METROPOLITAN GOVERNMENT OF NASHVILLE AND DAVIDSON COUNTY

STAFF RECOMMENDATION
3501 Byron Avenue, Lot 6
August 13, 2014

Application: New construction-infill
District: Elmington Place Neighborhood Conservation Zoning Overlay
Council District: 25
Map and Parcel Number: 104100090200CO
Applicant: Adam Huffstutter, Architect
Project Lead: Alison Asbrock

1 SITE PLAN
 S-1 SCALE: 1/4" = 1'-0"

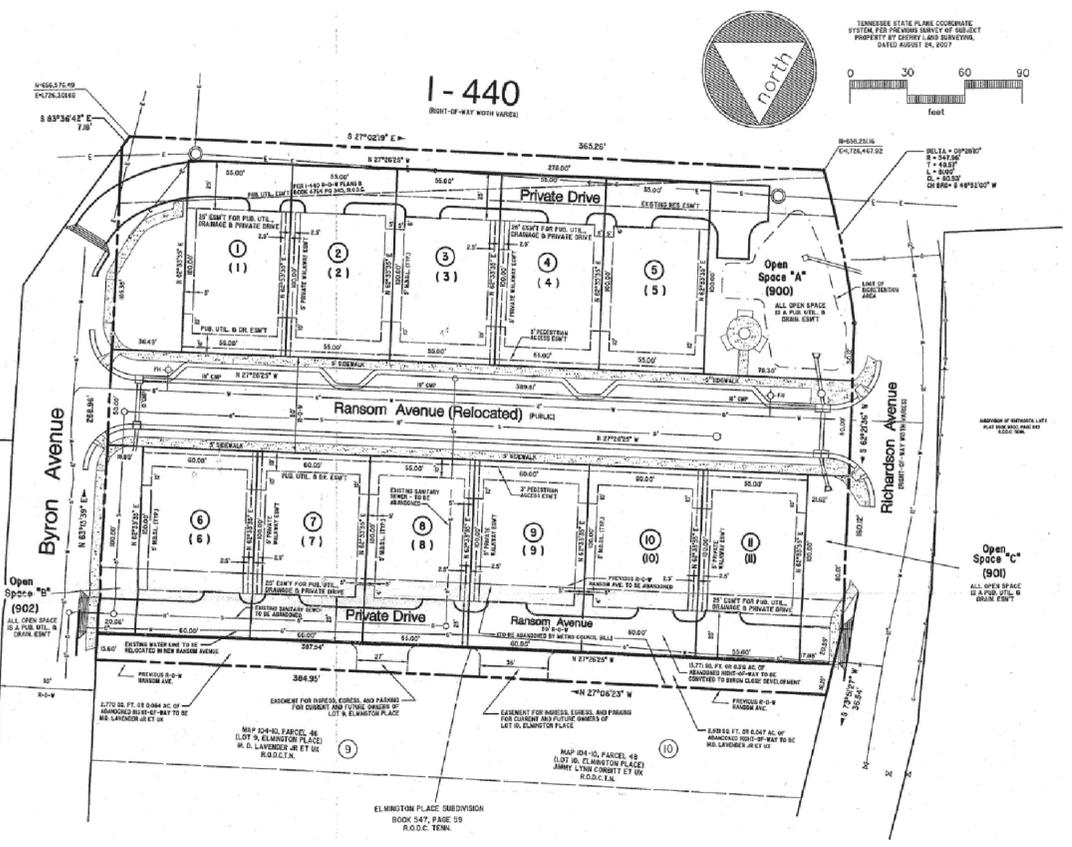
The front setback of ten feet (10') is appropriate for this development. Lots 3, 8, and 11 have approved front setbacks of ten feet (10'). The proposed side setbacks of five feet (5') and the rear setback of twenty-five feet (25') also meet base zoning.

As determined in July 2012, the side setback for corner lots is twenty-five feet (25') to create green space that provides a similar setback visual to the historic setbacks along Byron Avenue. The proposed home meets that requirement.

Vehicular access for this lot will be from the rear, accessed by a rear alley.

1
A-1
FRONT ELEVATION
SCALE: 1/8" = 1'-0"

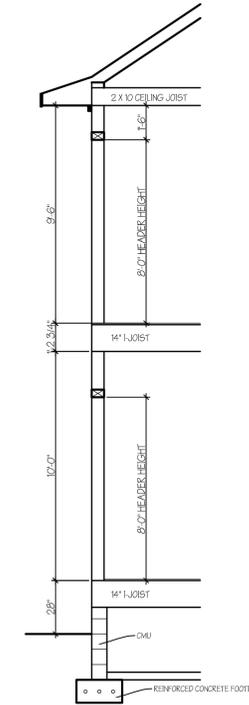
Height & Scale: The proposed building is two and a half stories (2.5) with a foundation height of two feet four inches (2'4"). The proposed construction on lot 6 is approximately thirty-four feet from grade (34'). The majority of the historic homes are one to one and a half-story with several two-story homes in the area. The historic two-story homes range from twenty-eight feet (28') to thirty-five feet (35'). On lot 11 of the same complex, infill construction of a two-story home was approved at thirty-seven feet (37'). The proposed infill falls within the range of the historic and infill context.

The eaves are approximately twenty-one feet (21') from finished floor. The distance from finished floor to the porch eaves is approximately nine feet (9') with a porch ridge height of twelve feet (12').

The proposed foundation is stone veneer and the cladding is primarily brick. The porch has a concrete floor and the porch posts are round posts on a brick pedestal. The material of the posts and the railing is not indicated. The chimney will be brick. Plans indicate a lap siding of unknown material in the gable fields with a four inch reveal (4"). The cladding on the dormer also appears to be a lap siding but with a reveal larger than the five inch (5"). The material of the lap siding is not indicated. Staff recommends that all lap siding be no more than five inches (5"), as has been required by the Commission in the past based on typical historic conditions.

The front dormer sits two feet (2') from the ridgeline and two feet (2') from the front façade as required. Staff finds the project meets section II.B.1.e.

- Staff verify the construction height of the foundation and floor system in the field to ensure that the finished floor line of the new construction is compatible;
- Staff provide final review all materials and the rear wall;
- The maximum reveal of the siding on the front dormer be five inches (5”);
- A second entrance be added to the Byron Avenue façade; and
- A corresponding walkway to the Byron Avenue entrance be added.

SOUTH
ELEVATION
A-4

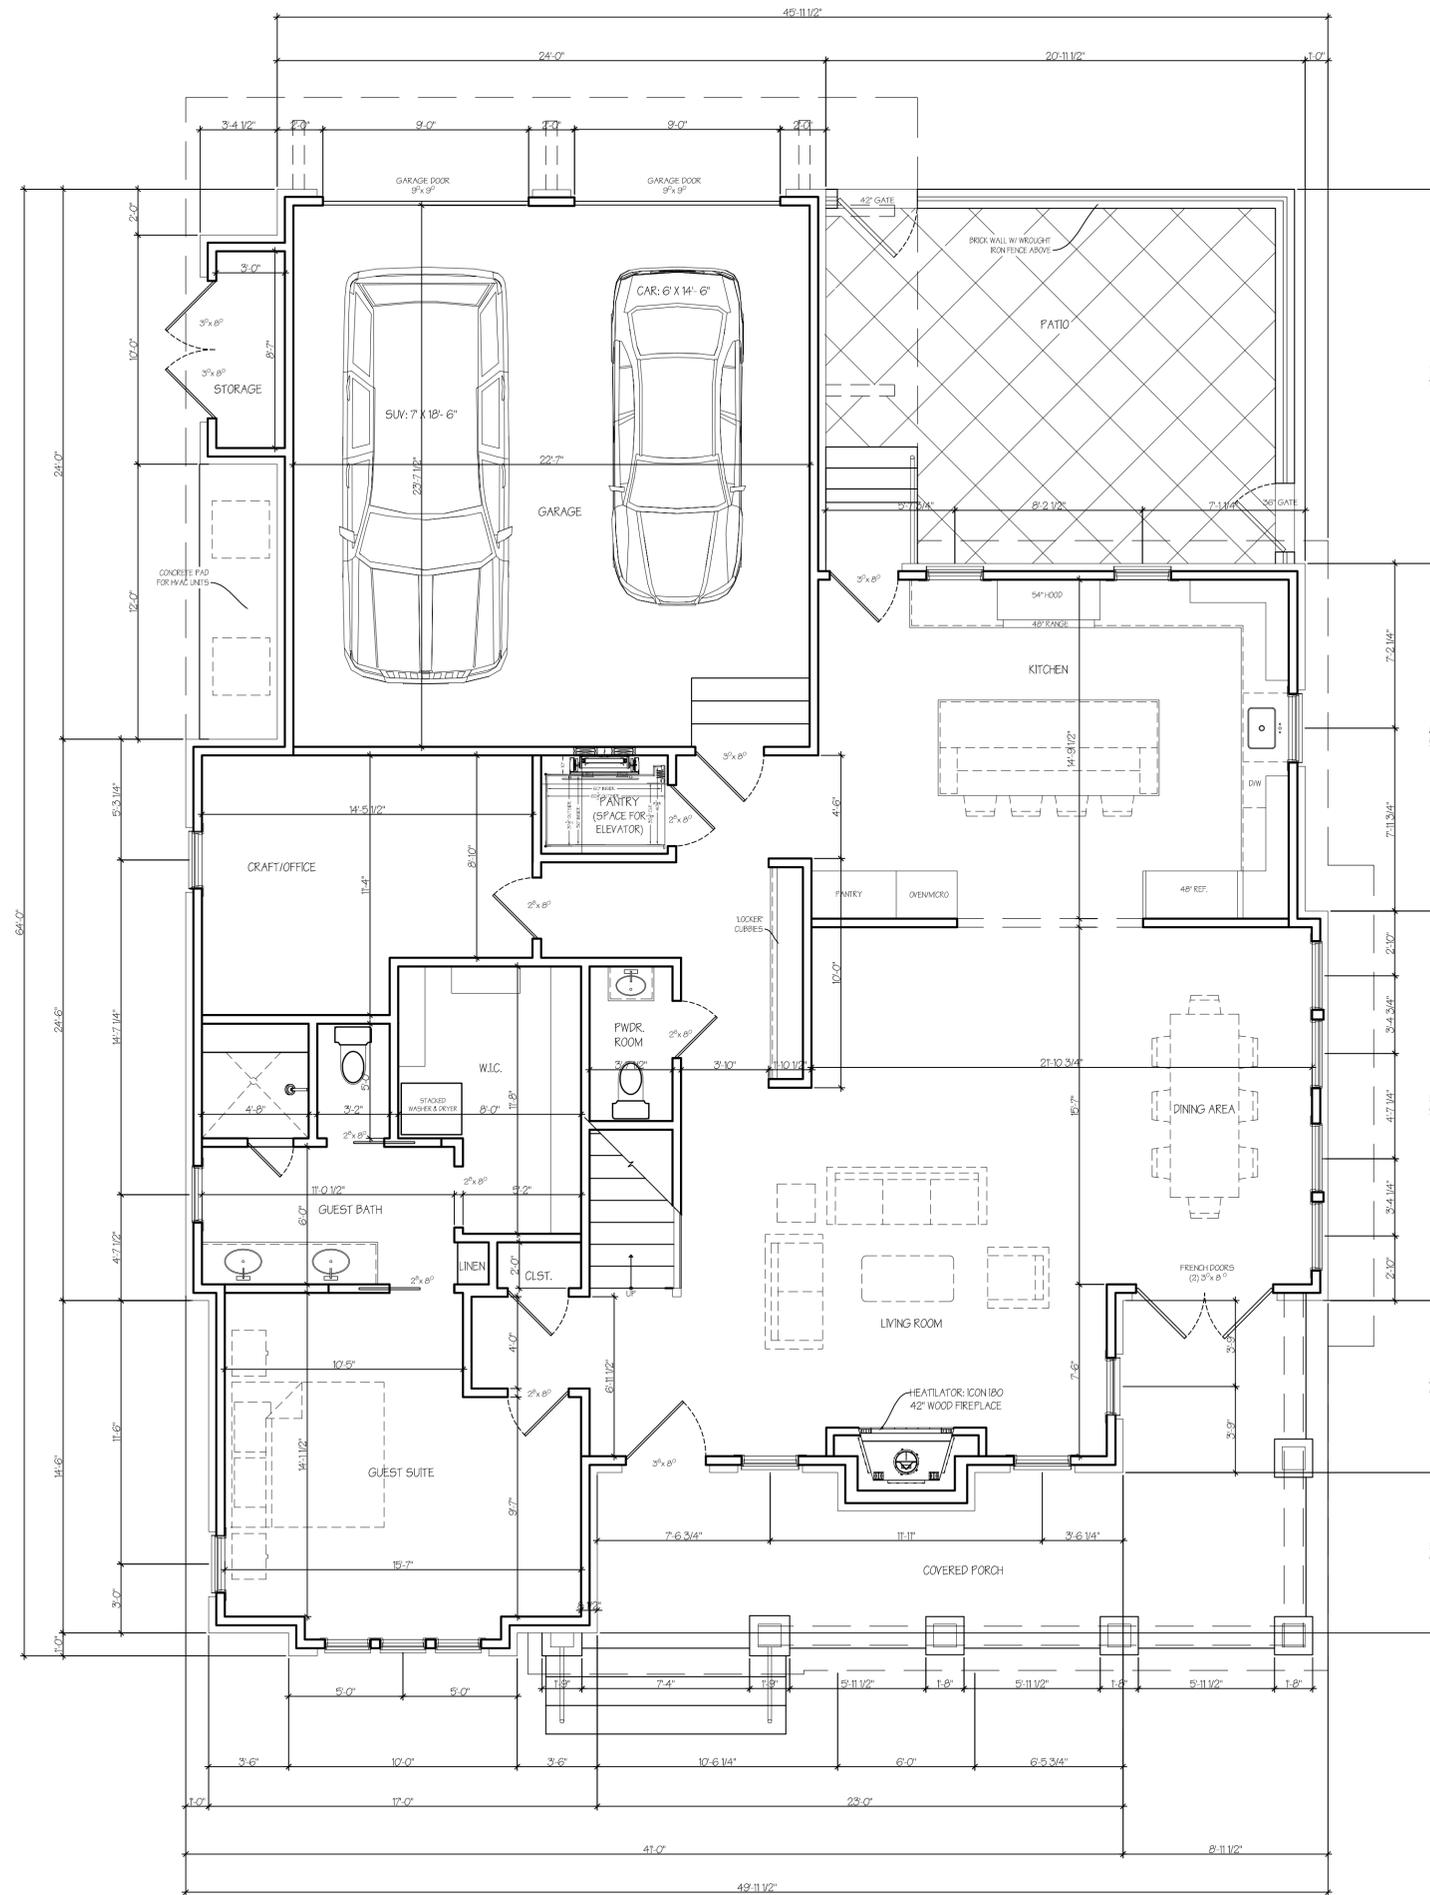
The longest wall expanse without a window is approximately sixteen feet (16') on the north façade and twenty-three feet on the south façade (23'). Although highly visible, Staff finds this is appropriate on the north façade as this wall is the garage side wall, it is accented with an eave bracket; and it is recessed approximately twenty feet (20') from the bulk of the side wall and will be obscured by a wall. On the south façade, this lack of window openings is also appropriate as it is located on the upper story, setback from the main portion of the façade, and therefore has low visibility from the street.

Appurtenances & Utilities: The mechanical units are located on the south facade past the mid-point of the house. The pad for the units is recessed behind the main portion of the south facade, leaving no view of the units from the street.

1 ROOF PLAN
A-9 SCALE: 1/8" = 1'-0"

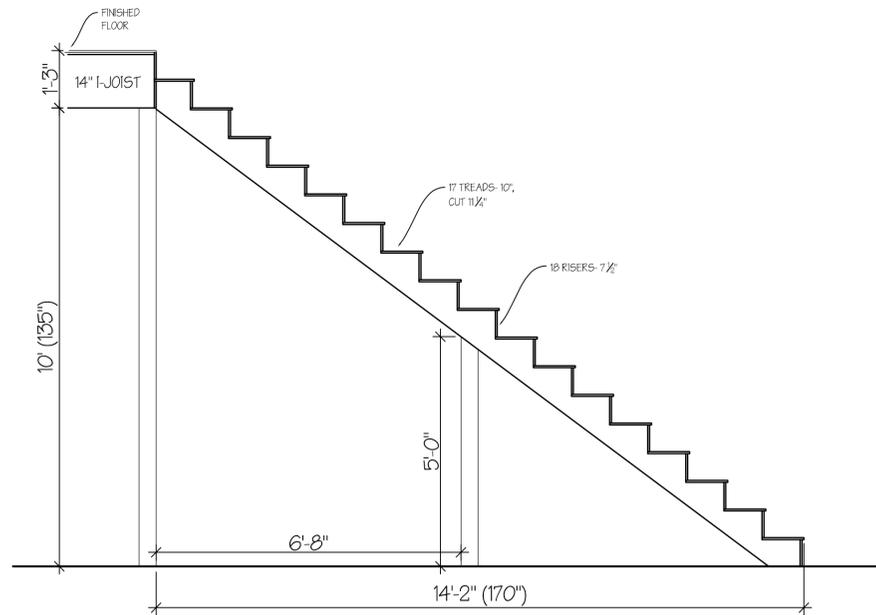
The roof is a cross-hipped roof with gables and a front gable dormer. The hipped roof is found on several two-story buildings in the district. The hipped and gable roof pitches of

8/12 fall within the range of historic pitches and are appropriate. Although more simple hipped forms are typically found, this complex roof system is appropriate for the corner lot as the north elevation should address Byron Avenue and appear as primary façade.

The front porch roof and rear secondary roof have a pitch of 4/12, consistent with the historic context for porch roofs and is appropriate.
